SERIAL: HNP-00-065
10CFR50.90

SHEARON HARRIS NUCLEAR POWER PLANT
DOCKET NO. 50-400/LICENSE NO. NPF-63
REQUEST FOR LICENSE AMENDMENT
TECHNICAL SPECIFICATIONS 3/4.4.9.2, 3/4.4.9.4

BASIS FOR CHANGE REQUEST

TECHNICAL SPECIFICATION PAGES

FIGURE 3.4-2

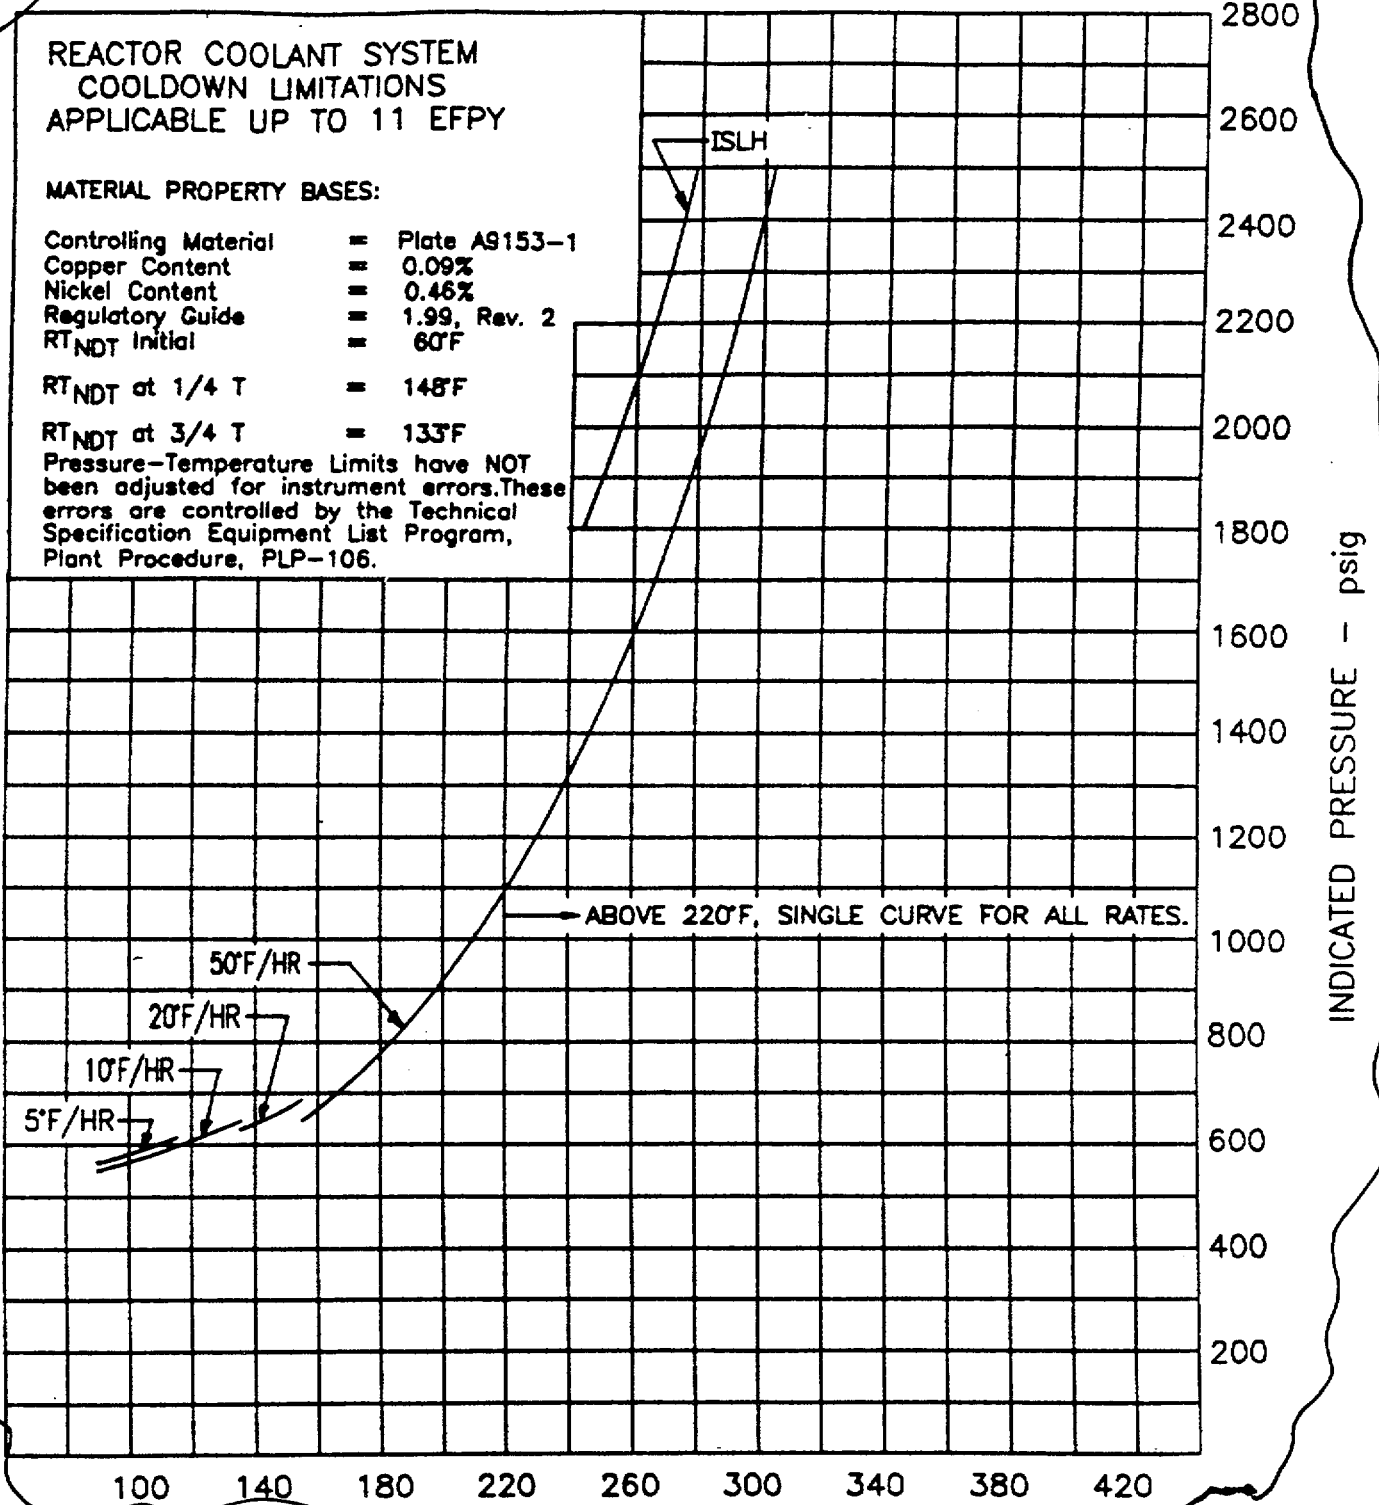
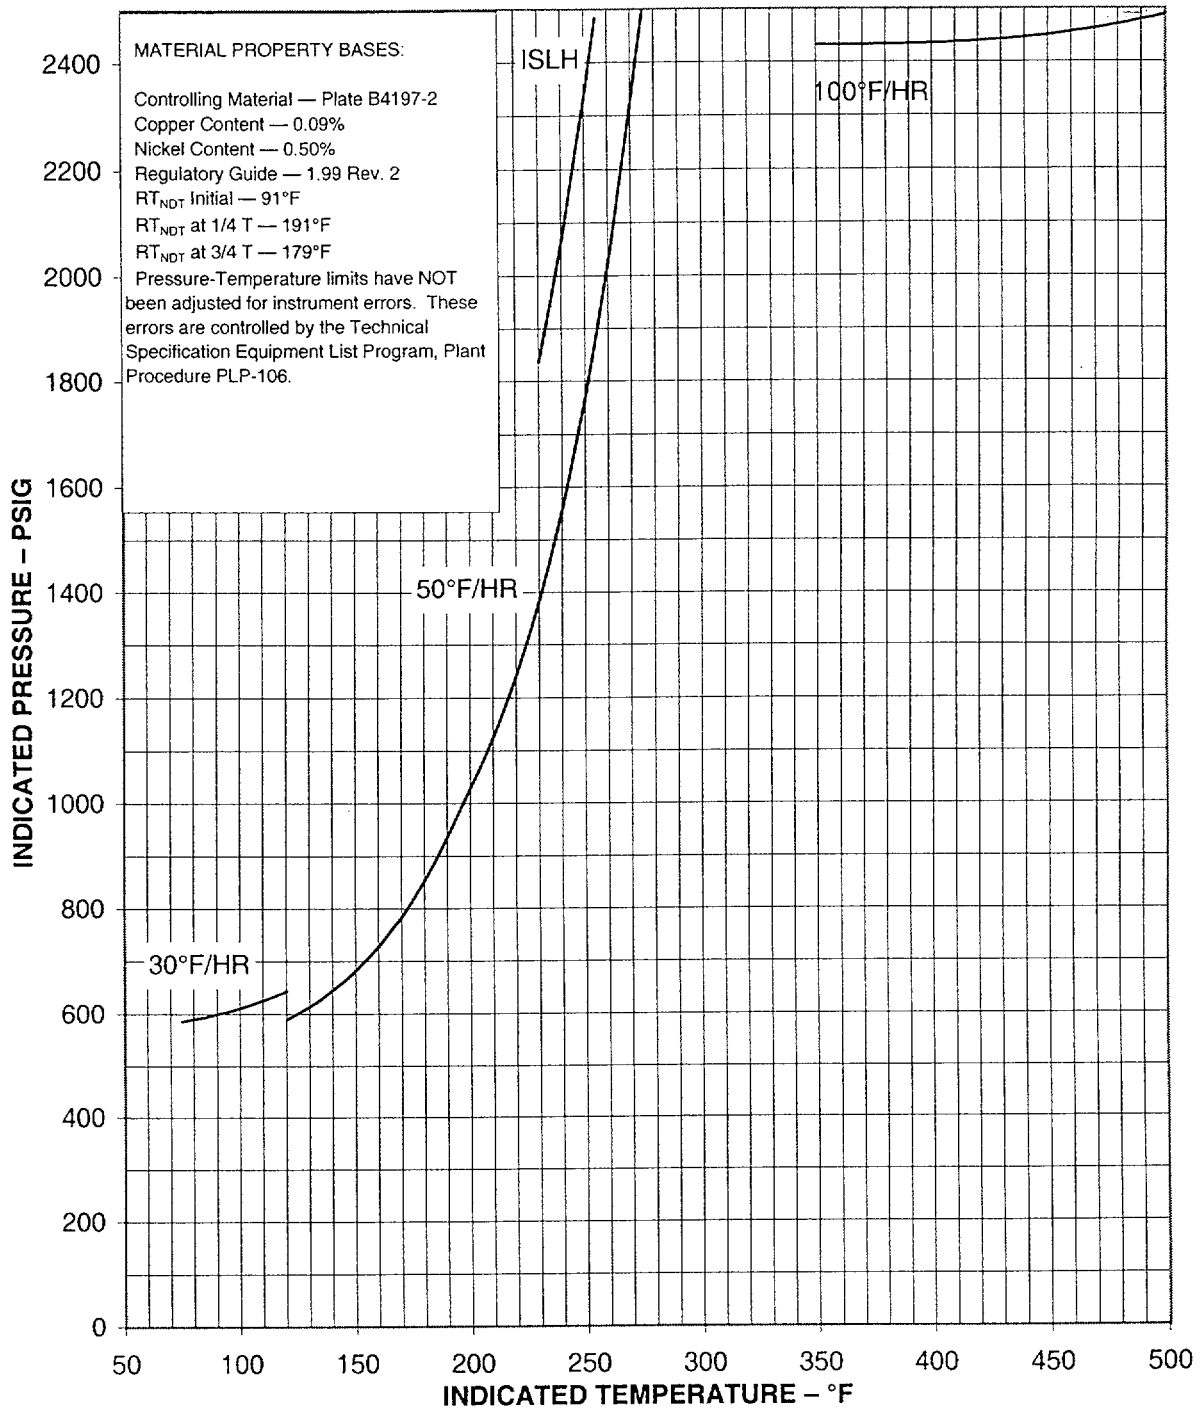
Delete

Insert

FIGURE 3.4-2
REACTOR COOLANT SYSTEM
COOLDOWN LIMITATIONS—APPLICABLE UP TO 36 EFPY

FIGURE 3.4-3

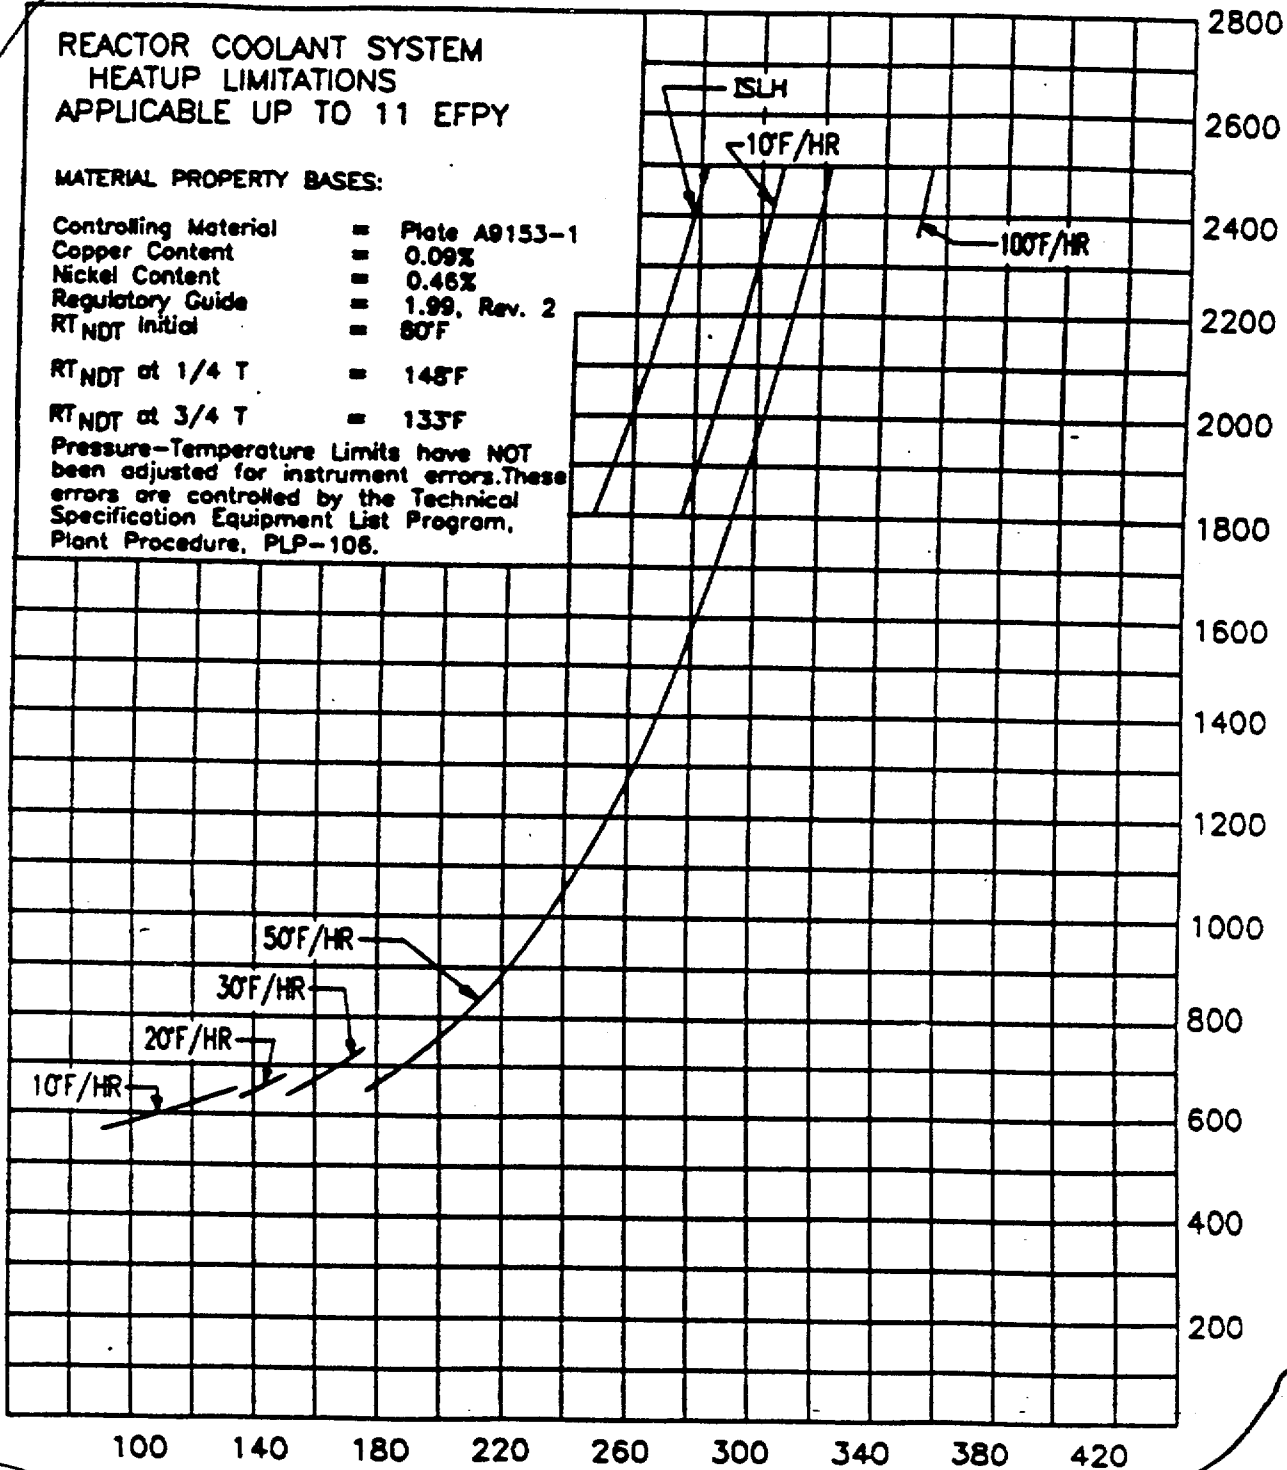
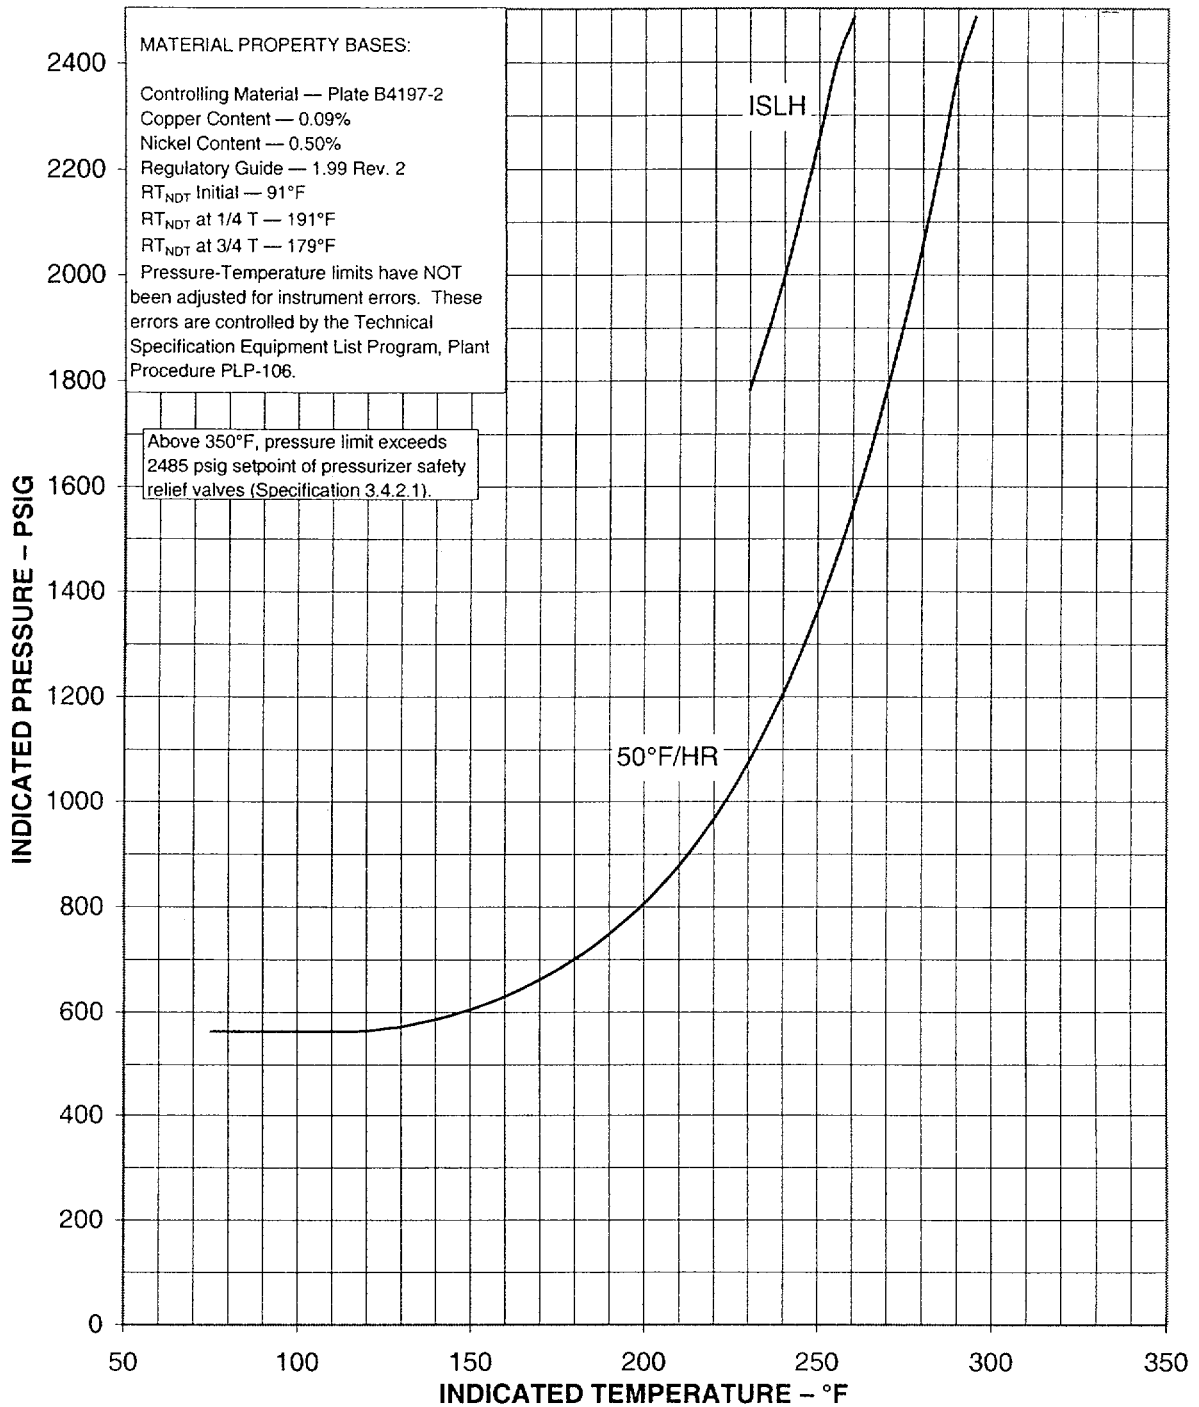
26 Add
11 Delete
Amendment No. 68 Delete

Insert

FIGURE 3.4-3
REACTOR COOLANT SYSTEM
HEATUP LIMITATIONS—APPLICABLE UP TO 36 EFPY

TABLE 4.4-6

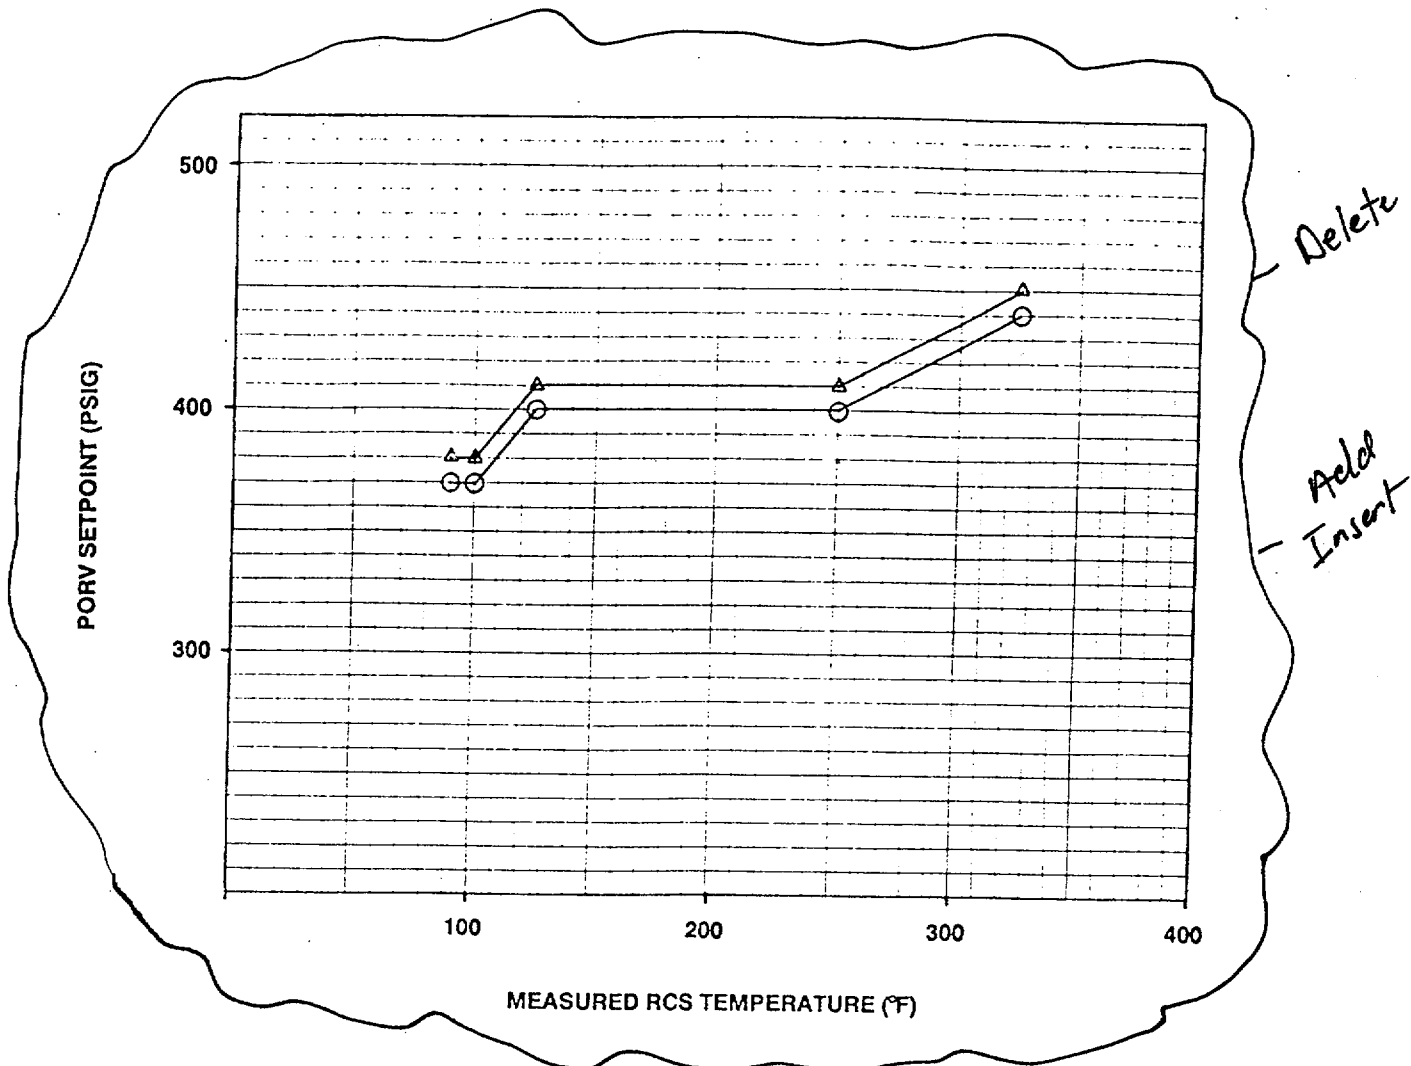
Handwritten annotations:
 - Above 350-155°F: ~~Delete~~ (120) Add
 - Above 50°F: Delete
 - Above 5°F/10°F: ~~Delete~~ (5) Add
 - Below <115°F: ~~Delete~~ (120) Add
 - Below 5°F/10°F: Add (30)

Handwritten annotations:
 - Above <135°F: ~~Delete~~ (350) Add
 - Above 10°F: ~~Delete~~ (50) Add
 - Above 50°F: Delete

<u>TEMPERATURE*</u>	<u>COOLDOWN IN ANY 1 HOUR PERIOD*</u>
350-120°F	50°F
< 120°F	30°F

<u>TEMPERATURE*</u>	<u>HEATUP IN ANY 1 HOUR PERIOD*</u>
<350°F	50°F

FIGURE 3.4-4

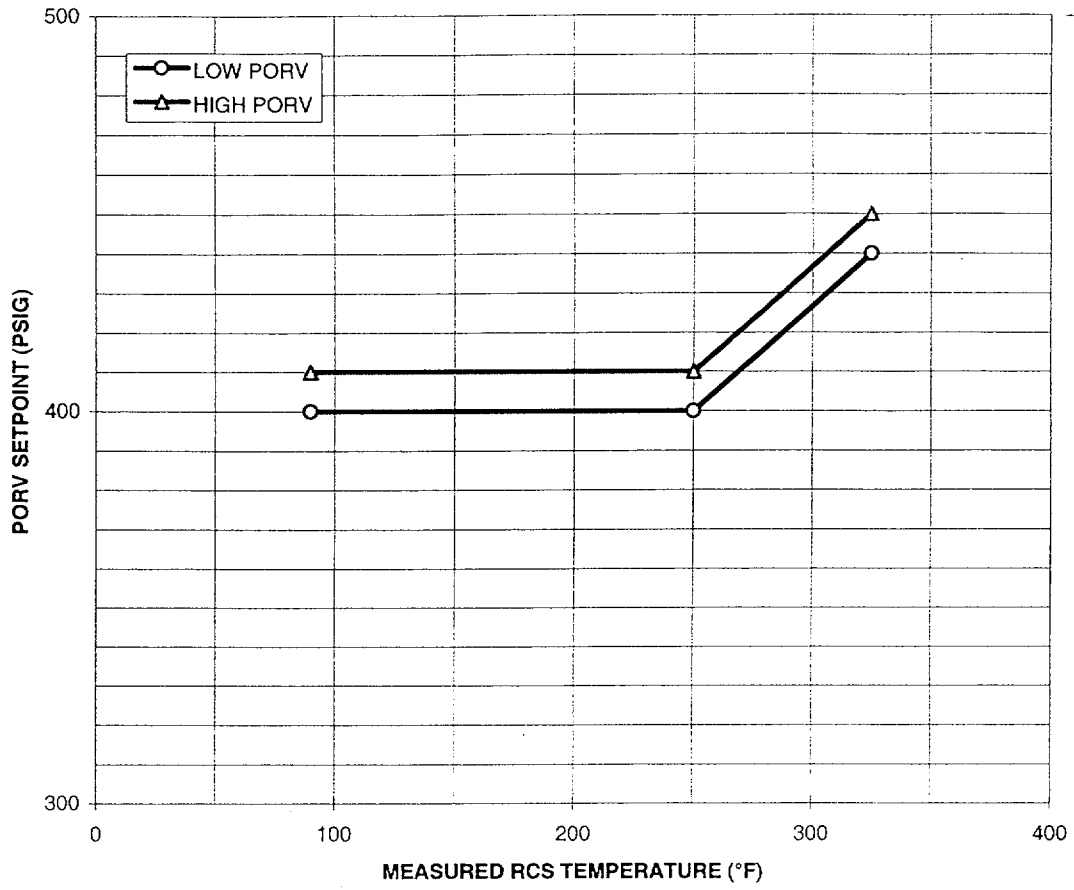
Delete

Delete

Delete

Insert

<u>RCS TEMP (°F)</u>	<u>LOW PORV* (psig)</u>	<u>HIGH PORV* (psig)</u>
90	400	410
250	400	410
325	440	450

* VALUES BASED ON 36 EFPY REACTOR VESSEL DATA
